Dragon Parc, Abercanaid NRW Model Review

Rev No: v3

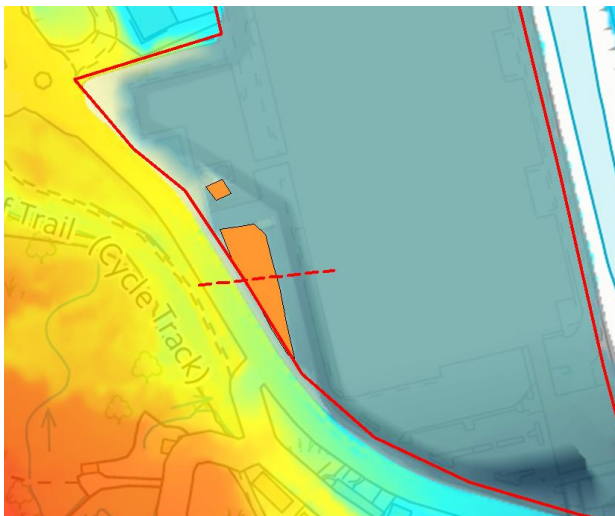
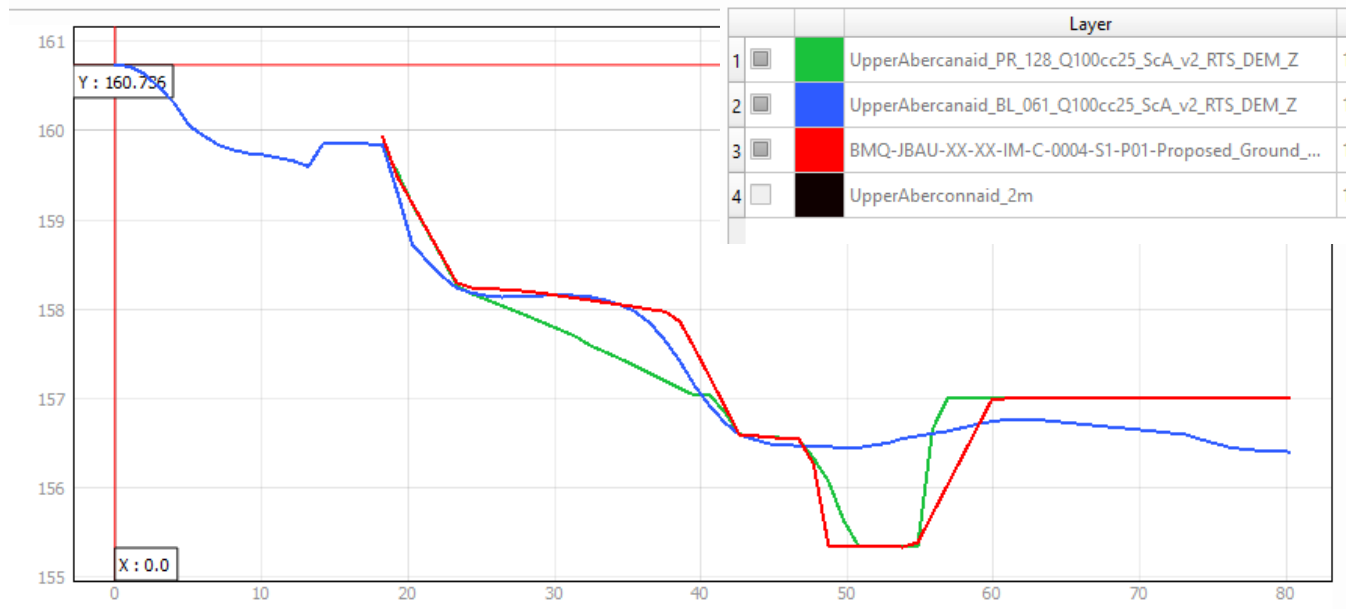
Proposed mitigation works are inputted into the 2D model using the proposed DEM and the culverts were inputted into the 1D model via SX links.

The .tbc file was checked alongside the 2d_bc layers for the proposed scenario showing the spills at the inflow to the culverts and the connections to the outflow from the pond connection.

The same base input LiDAR has been used for both the proposed and baseline scenario; the proposed scenario has included extra layers which alter the topography of the site (excavated area, LiDAR fix and a reprofile zshp).

The *2d_zsh_UpperAberconnaid_SiteLidarFixes_R_075* is not shown to be altering the DTM to 157mAOD as is noted in the attribute table. Please review this file to check it is altering the DTM as intended.

Mannings N values:

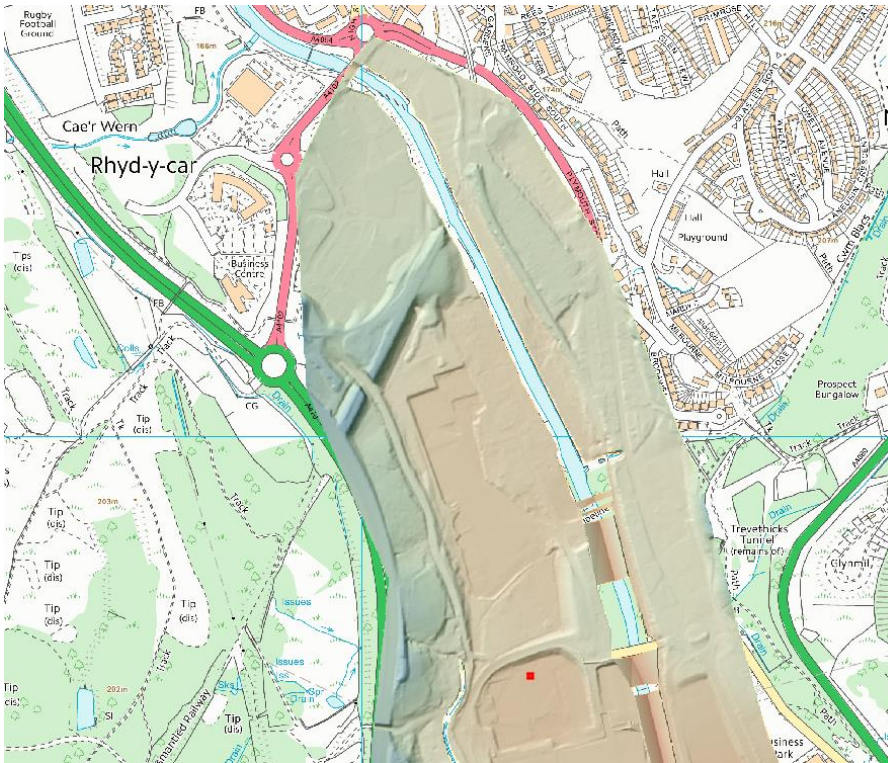
1D Mannings values in the culvert and ESTRY cross-sections are reasonable.

2D values in the .tmf are reasonable for the baseline scenario.

The .tmf values are used for both the baseline and proposed scenario; we would assume a difference in roughness values in the proposed scenario around the swales and site (access roads etc). Please review and update where necessary, justify decisions made within the report.

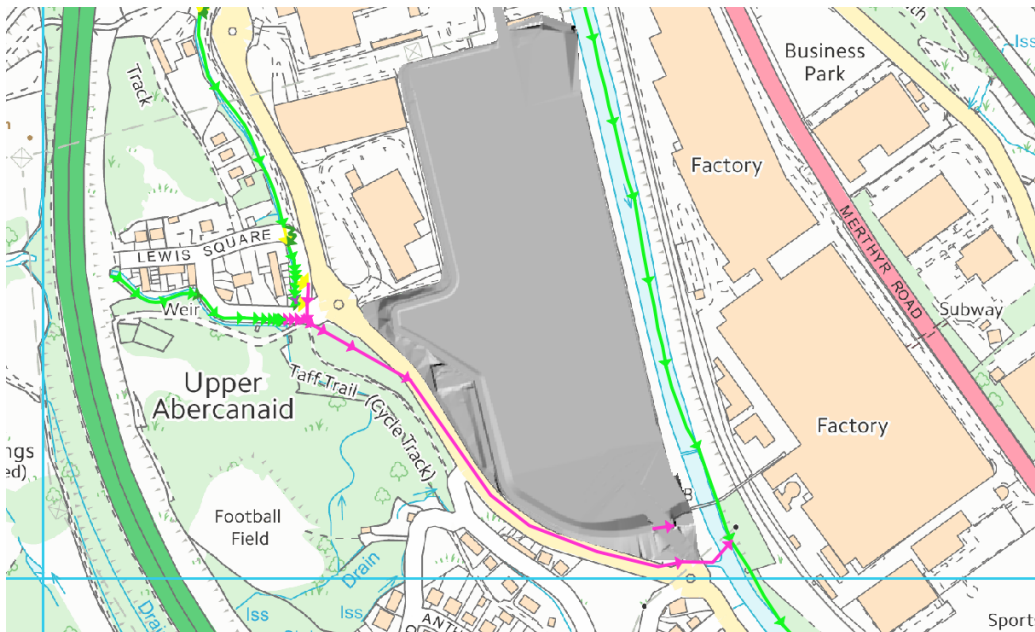
Meeting in October between NRW and Thomas Mackay highlighted that the culvert surveyors wouldn't survey the whole culvert as there are some blockages/obstacles. The survey report states that there is a section of the culvert which has not been surveyed, however the inlet, outfalls, junctions and route have been surveyed. Thomas Mackay have provided photos of the survey and uneven ground which lead to the abandonment of the survey. Information on the culvert survey has been inputted into the culvert survey reporting.

Please can the following questions be reviewed and inputted into the report:

When does the culvert reach capacity?

Do the two box culverts from the swale to the Taff back up into the site/swale?

In a period of high flow, will there be capacity in the culverts to also carry flow from the swale into the River Taff if the Taff is at high flows?

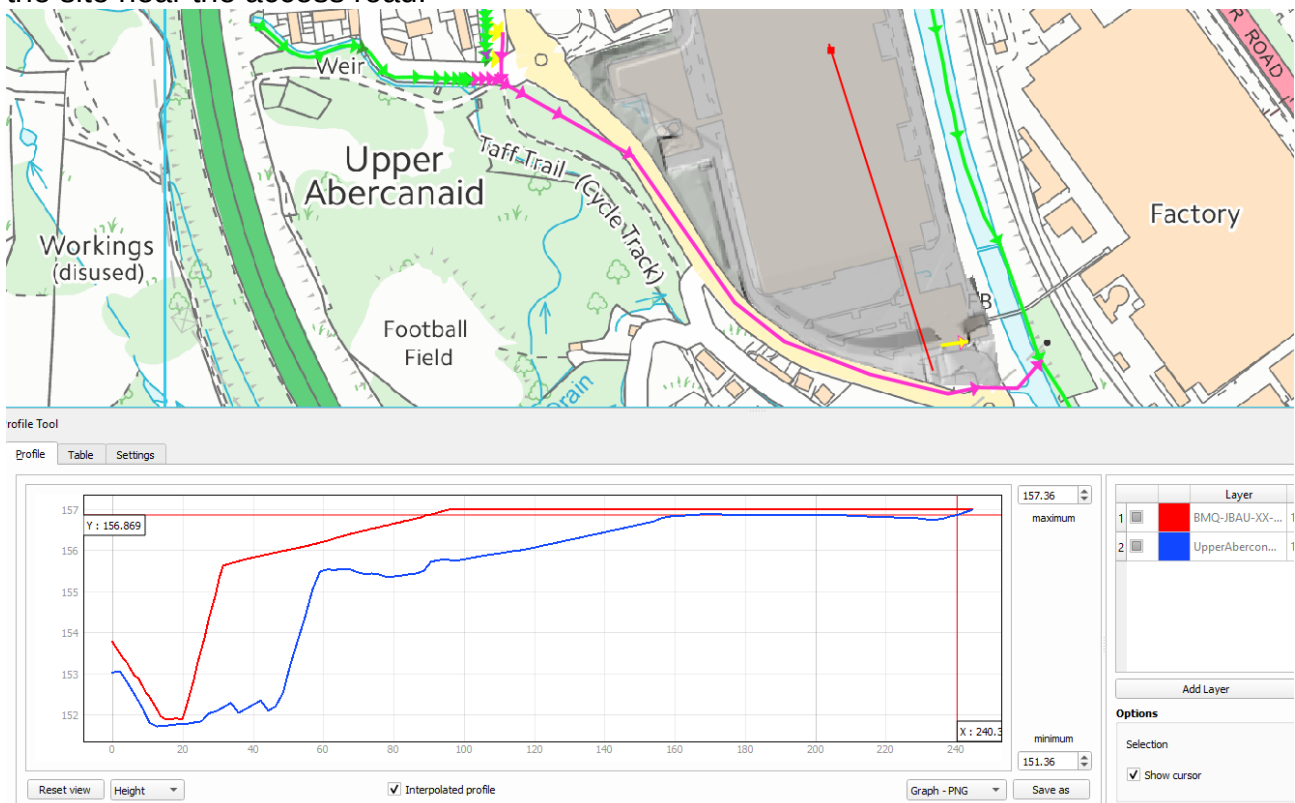
The culvert (pink) is shown in the 1D domain, there is a swale inputted in the 2D domain (proposed ground modelling output) which drains to the south of the site. This then is connected to the River Taff by two culverts.

The site has been elevated to a consistent level of 157mAOD (Q1000 SoP) as stated in the report.

The swale has been reduced to a level of approximately 151.8mAOD at the south end of the site near the access road.

Q100+25% depths:

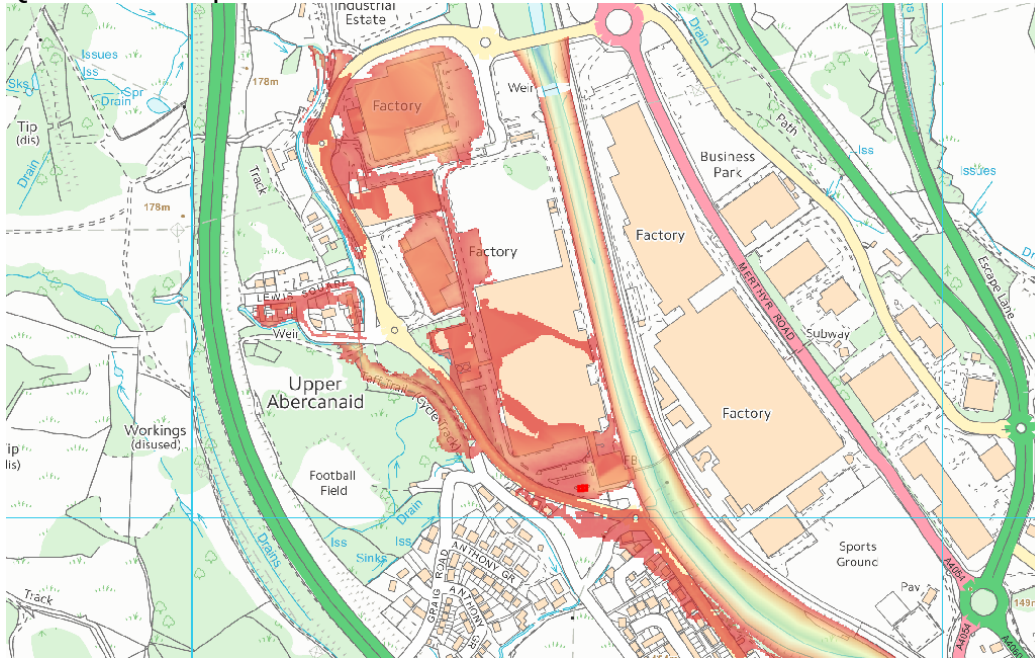
Primary source of flooding is from the Nant Canaid West as the channel and culvert are exceeded.

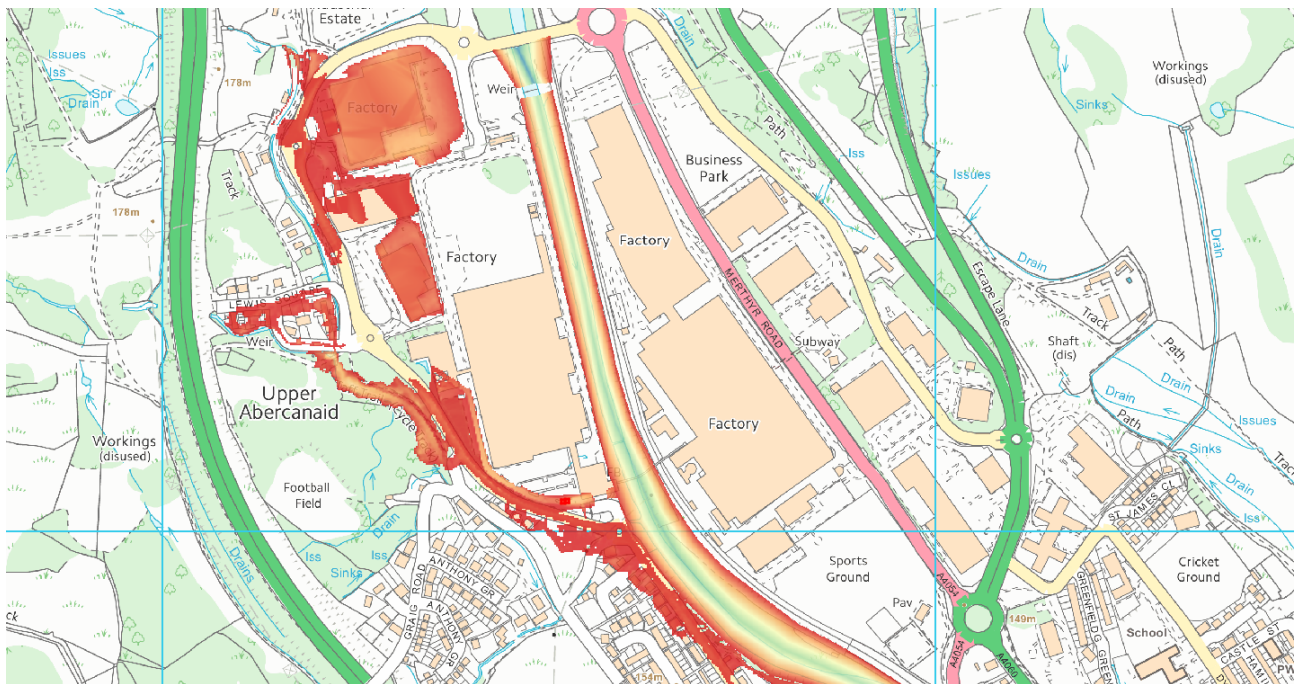
Blockage scenarios have been run and the proposed results have been included in the results files as well as in the model report (30% and 95%).

We want to be confident in the model, as there is not a full culvert survey, the sensitivity events such as blockage (30% & 95%) will be used to review the baseline scenario.

Please provide the baseline blockage scenario results files so these can be compared with the proposed scenario to check for detriment.

The FCA will require comments on the comparisons between the baseline and proposed 95% blockage scenarios as this is the design event for the site.

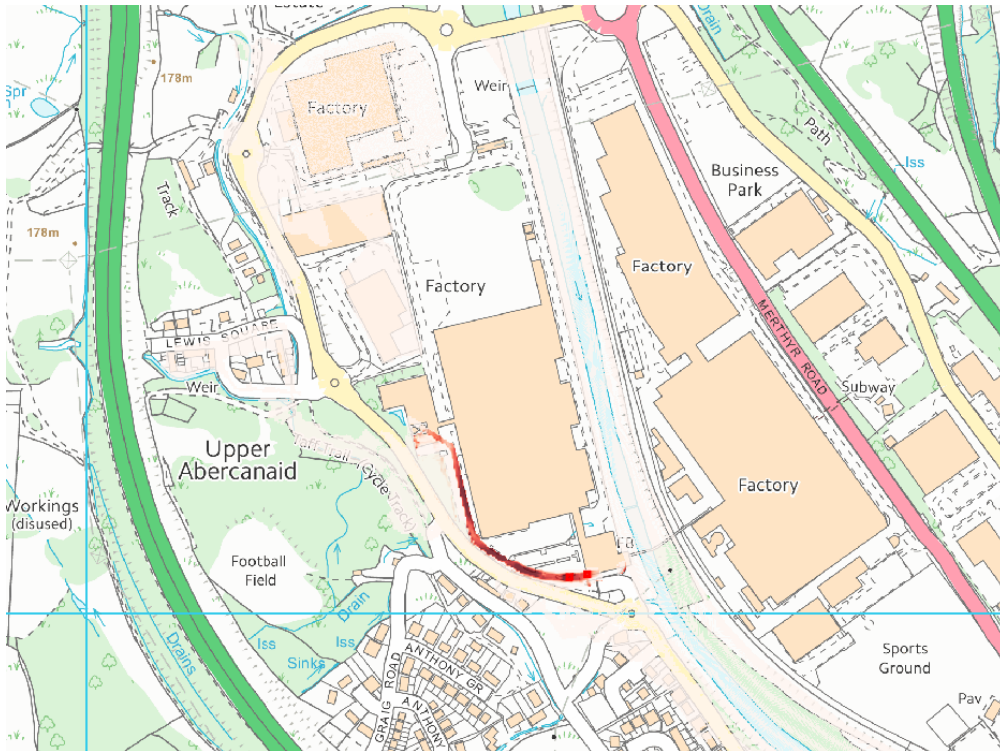
p16-p18 states that there are no adverse impacts on third-parties due to the proposed works in the 1% and 0.1% AEP. However, as the Development Control team/Planning have asked for the 95% blockage scenario as the design event (email dated 13th November 2019) there needs to be a comparison between the baseline and proposed scenario to look at third party impacts.

The area of detriment in the Q100+25% which is over 5mm is maintained within the site boundary, however this is not the design scenario:
